ADDENDUM NO: 01
PROJECT NAME: A New Baseball/Softball Practice Facility
Huntsville High School
PROJECT ADDRESS: Huntsville, AR
PROJECT NO: 2430

DATE: 12.20.2024
HIGHT JACKSON ASSOCIATES
ROGERS, AR
ARCHITECTS AND PLANNERS

Addendum No. 01

Huntsville HS Indoor BB/SB Practice Facility

DEMOLITION PLAN
 SHEET
C2
 COPYRIGHT 2022
 THESE DRAWINGS AND SPECIFICATIONS ARE THE EXCLUSIVE PROPERTY OF HIGHT JACKSON ASSOCIATES, P.A. USE OR REPRODUCTION IS PROHIBITED WITHOUT WRITTEN CONSENT.

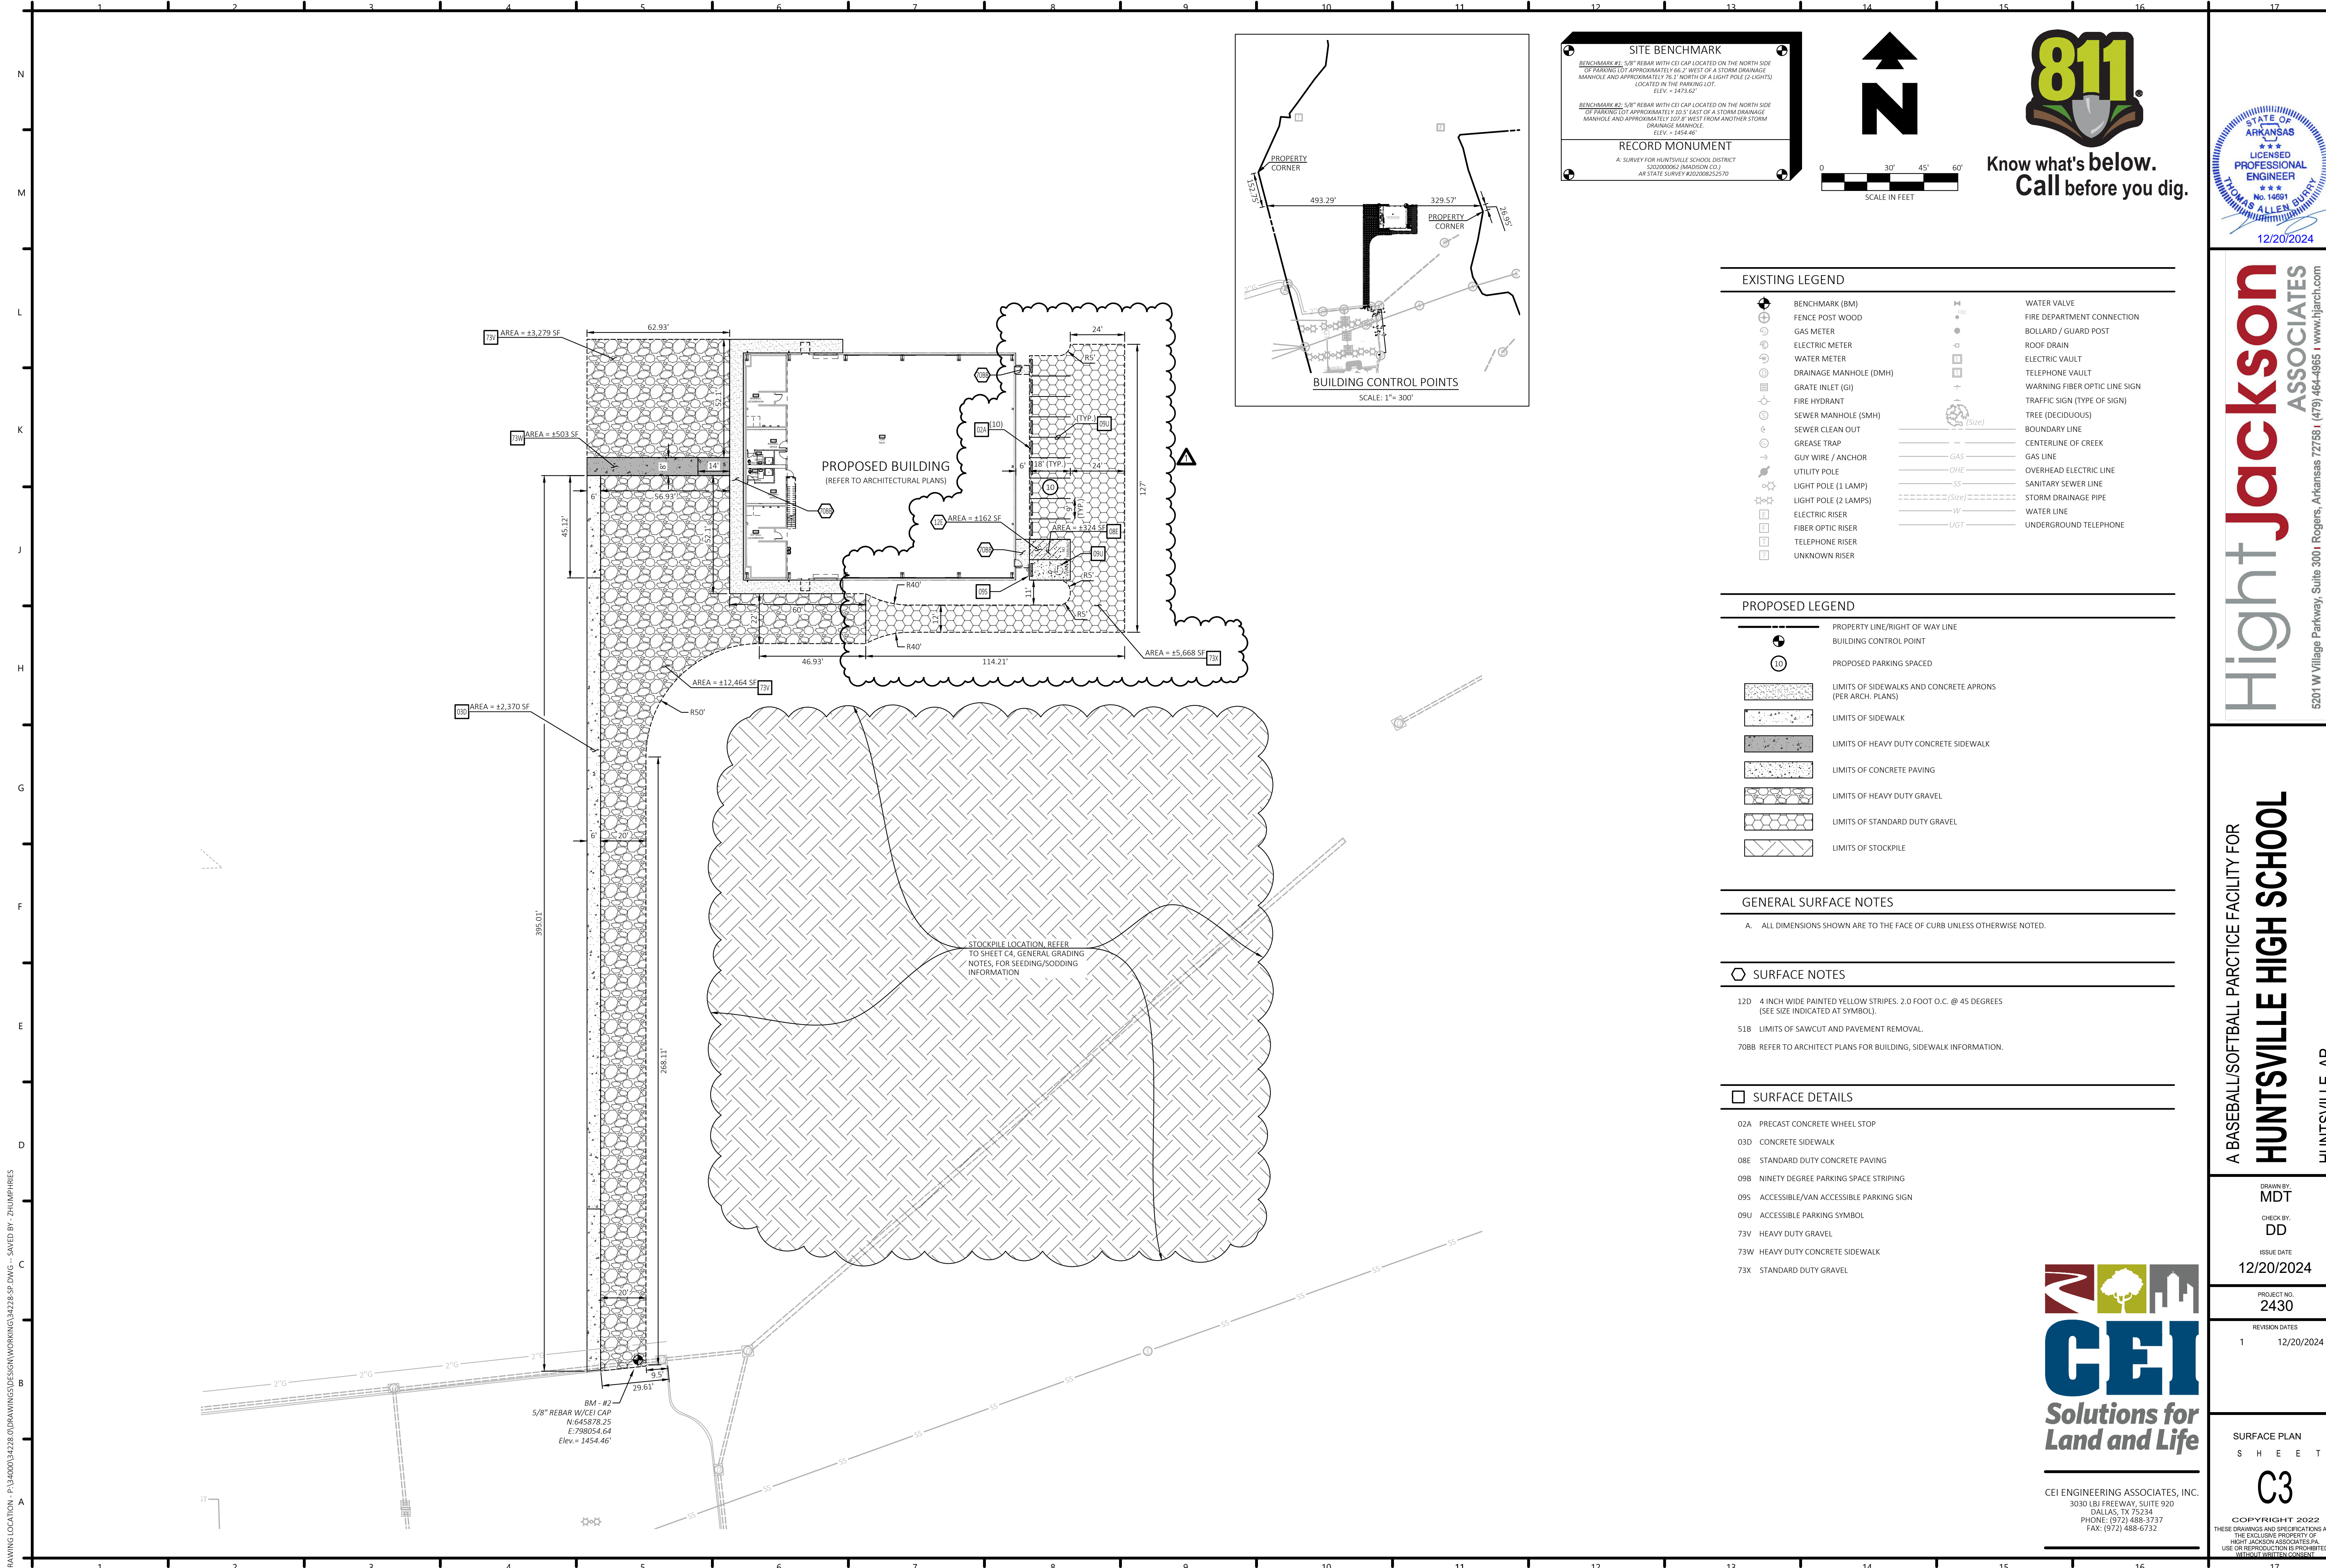
- Item No. 1: **Refer to attached, revised Civil Sheets C1 through C9:**
- a) See revised items clouded on the attached Civil drawings.
 - b) Delete the parking along the east side of the existing parking lot.
 - c) Delete the heavy duty asphalt paving on the access drive from the existing parking lot to the building. Provide only 12” of gravel as specified.
 - d) Add gravel parking as shown on the east side of the building.
 - e) See other notes and items shown clouded.
